Source: S1
Title: Collection of CRs to 22.129 on handover
Document for: Approval
Agenda Item: 5.1.3

S1-99500	22.129	002	R99	SMS handover requirement clarification
S1-99516	22.129	003	R99	GSM UMTS Handover
S1-99533	22.129	004	R99	Revised terminology to 22.129
S1-99540	22.129	005	R99	For R99 there can only be one target PLMN for HO in addition to the serving PLMN for R99 in a given geographical area.
S1-99541	22.129	006	R99	from 489 - Clarification of the scope of mandatory requirements
S1-99565	22.129	007	R99	Removes all non-R99 requirements, by changing them into Cross phase compatibility requirements which apply to R99.

Subject: SMS handover requirement clarification

Figure 1: Example for inter-PLMN handover

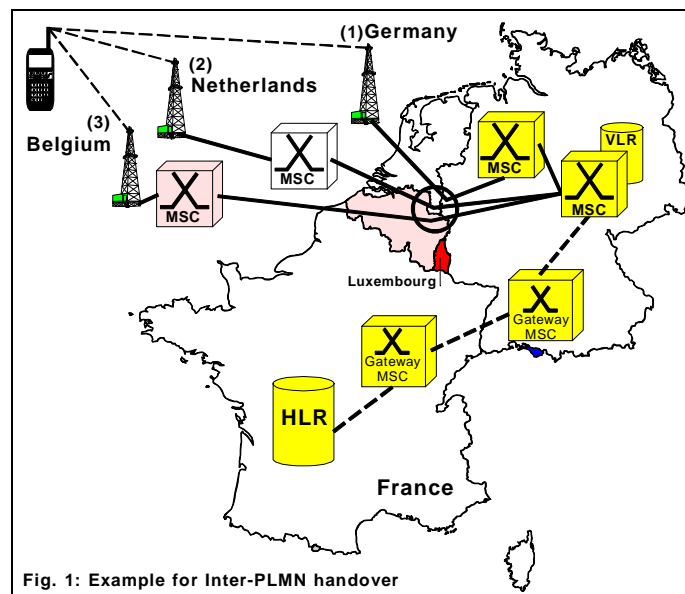
3rd Change [Illustration of 'Subscriber Inter-PLMN handover preference' in non-normative annex]

When the French subscriber registered in a German network roams near the border to the Netherlands, inter-network handover may occur. In this case a Dutch network is the *target network*. After handover, the anchor MSC located in a German network continues to control the call. The German network remains the *visited network* where the subscriber is registered. The subscriber's location information stored in the HLR remains unchanged. The signalling and circuit switched connections between the anchor MSC and the previously serving MSC in the German network will be released when the Mobile Station (MS) is served by a cell within a Dutch network. The Dutch network becomes the *serving network*. From the Dutch network the subscriber may be handed over to a Belgian network.
